**RE: Grading and Drainage Plan for Tr. A Lands of Sullivan and Hiller (L24-D5)
(PWDN 125) Dated November 27, 2000**

Case Comments Report

Permit: PWDN 125

Title: Grade and Drain
Client: Cossey
County of Bernalillo

VICINITY MAP

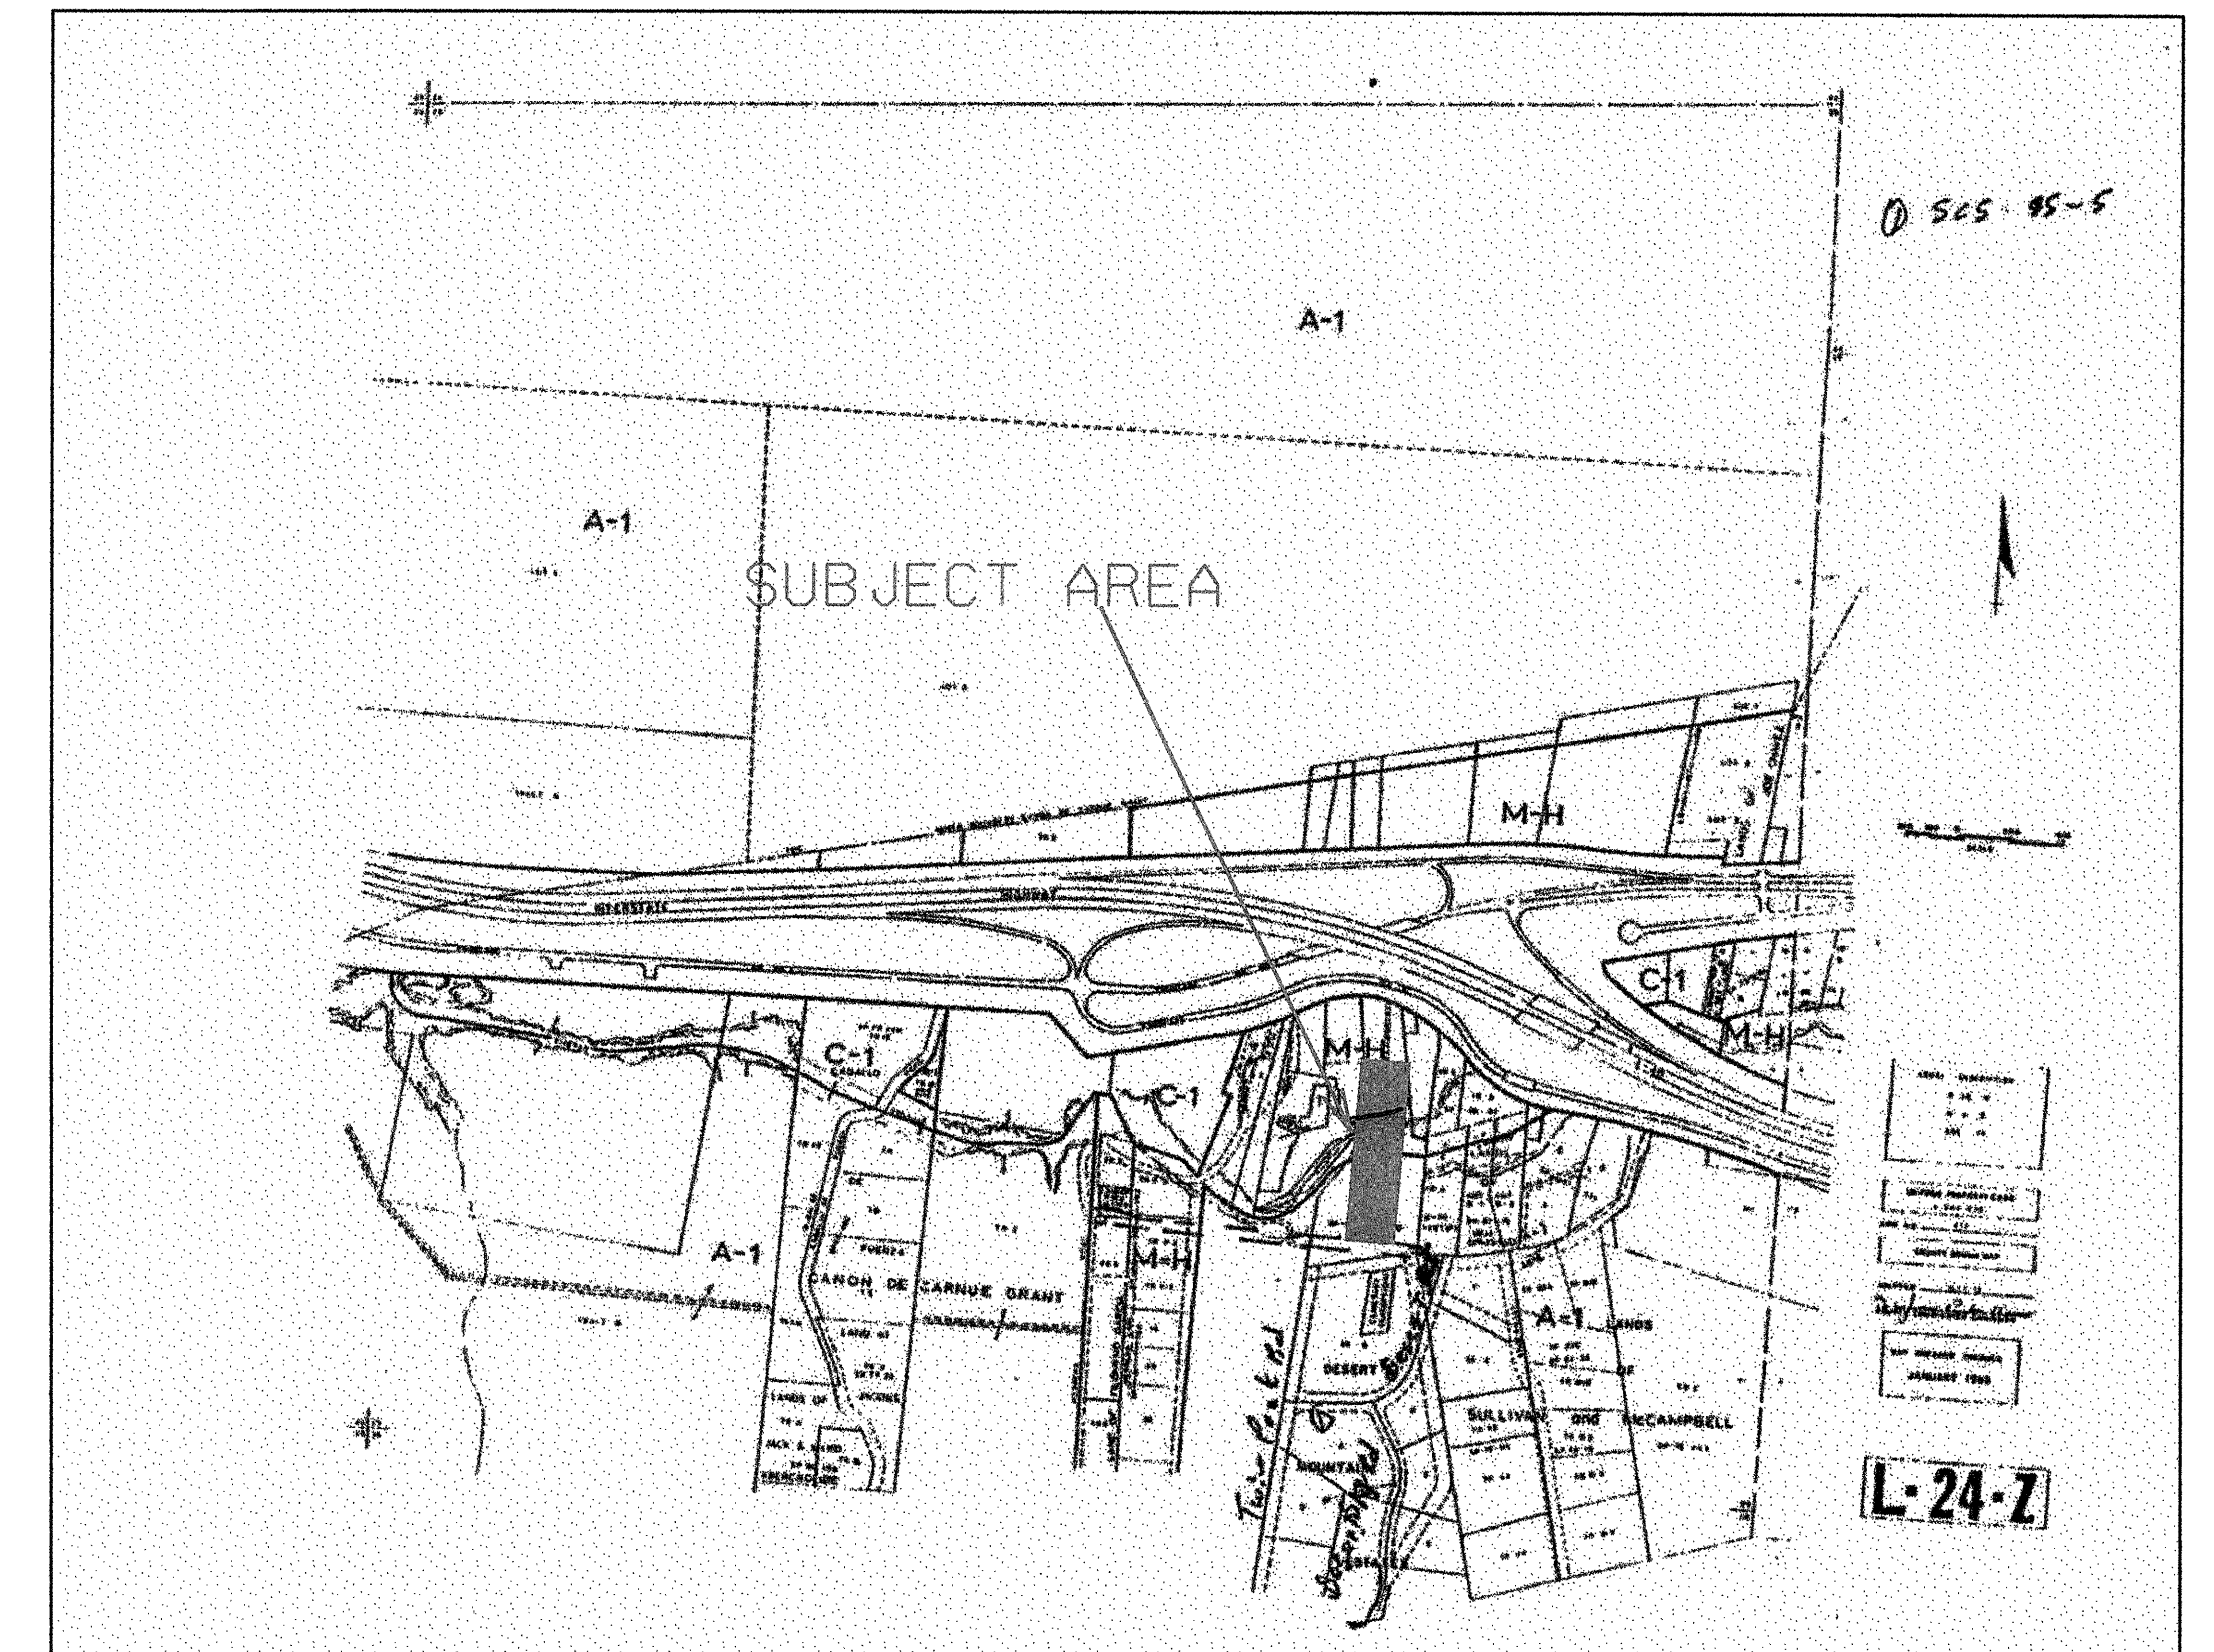
1. A drainage easement needs to be submitted to AMAFCA for the 100 year floodplain in the Tijeras Arroyo.
2. Please improve on the location and dimensions of the property on the vicinity map. The vicinity map is hard to read. Please put some street names, Tijeras Arroyo and the subject lot on the contributing watershed map.
3. I have attached the floodplain map for the Tijeras Arroyo next to your site. I believe that the location is around section "BX and BY". Please transfer the 100 year water surface from the floodplain map to your drawing.

CONTRIBUTING WATERSHED

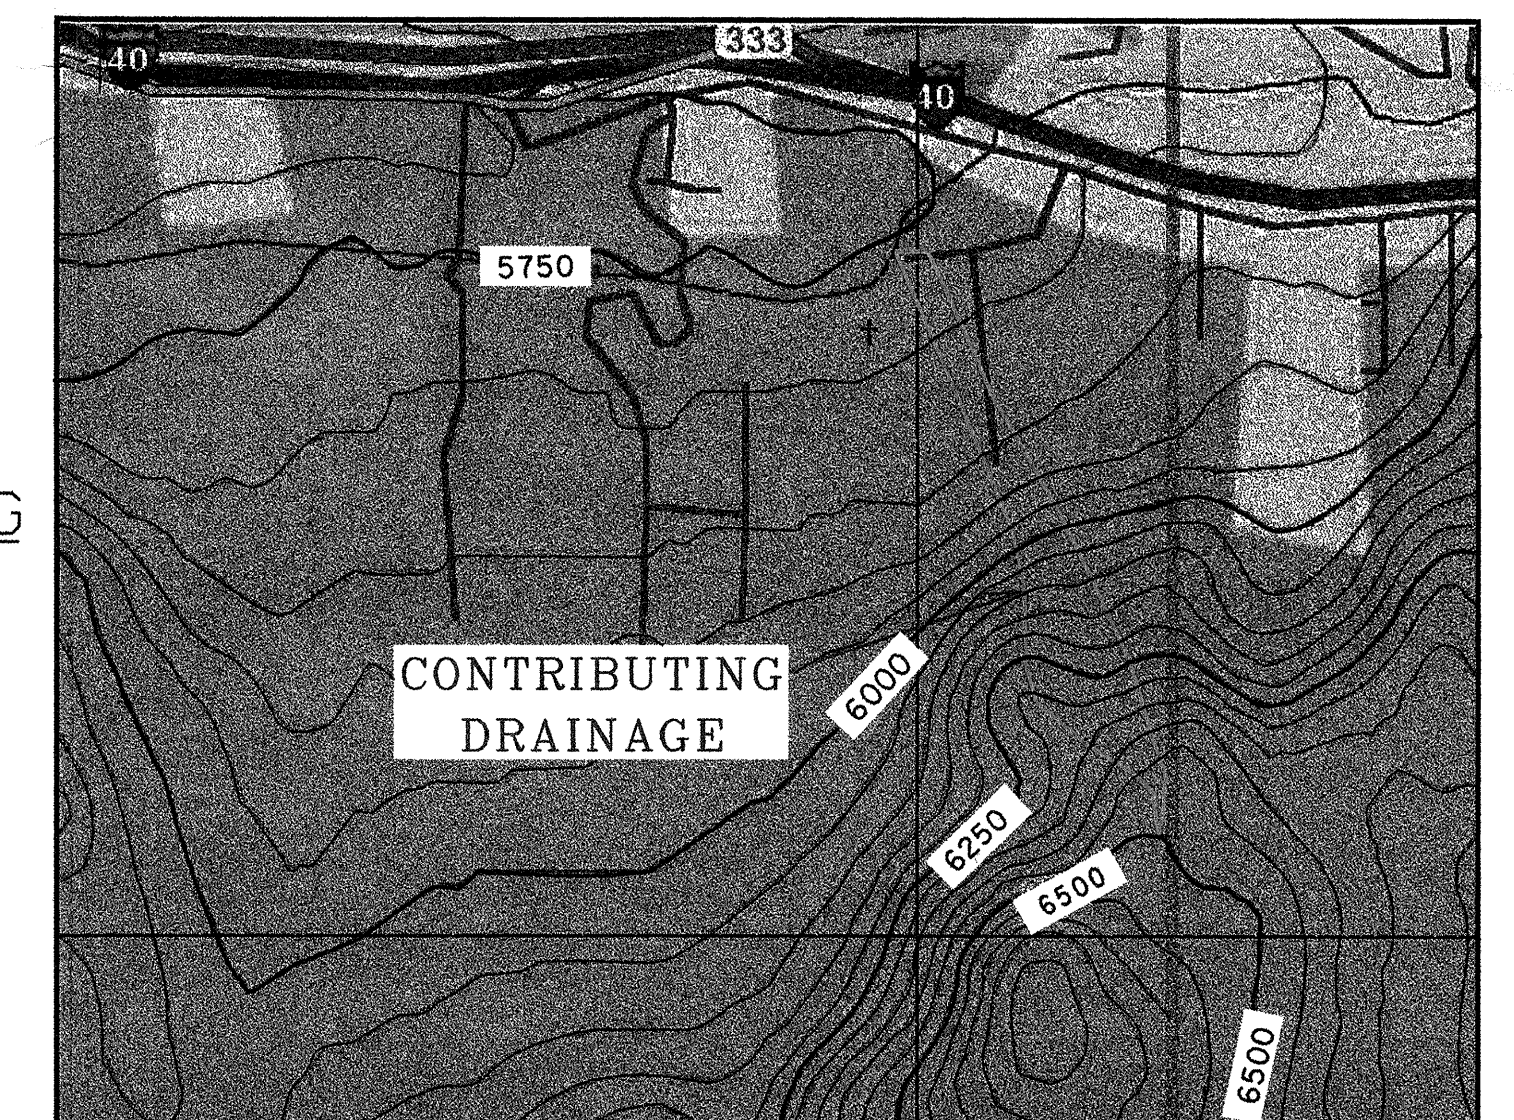
4. The off site basin shown drops 750 feet as shown on the "contributing watershed" drawing. The slope of this basin requires a different land treatment analysis than shown in the calculations. (Table A-4 of the DPM sec.22.2). It would help if the contributing watershed drawing was more clear.

1. The slope for the offsite drainage basin appears to be greater than 10%. Table A-4 indicates a land treatment of undeveloped land with slopes greater than 10% to be land treatment "B".
2. Provide a copy of the easement for the channel.
3. Gabions for the arroyo are unnecessary for this grading and drainage plan.
4. Provide erosion protection on the western side of the channel. Erosion protection should be suitable for velocities.
5. The minor contours are not legible on the Contributing Watershed Drawing.
6. Provide one copy resubmittal drawing.
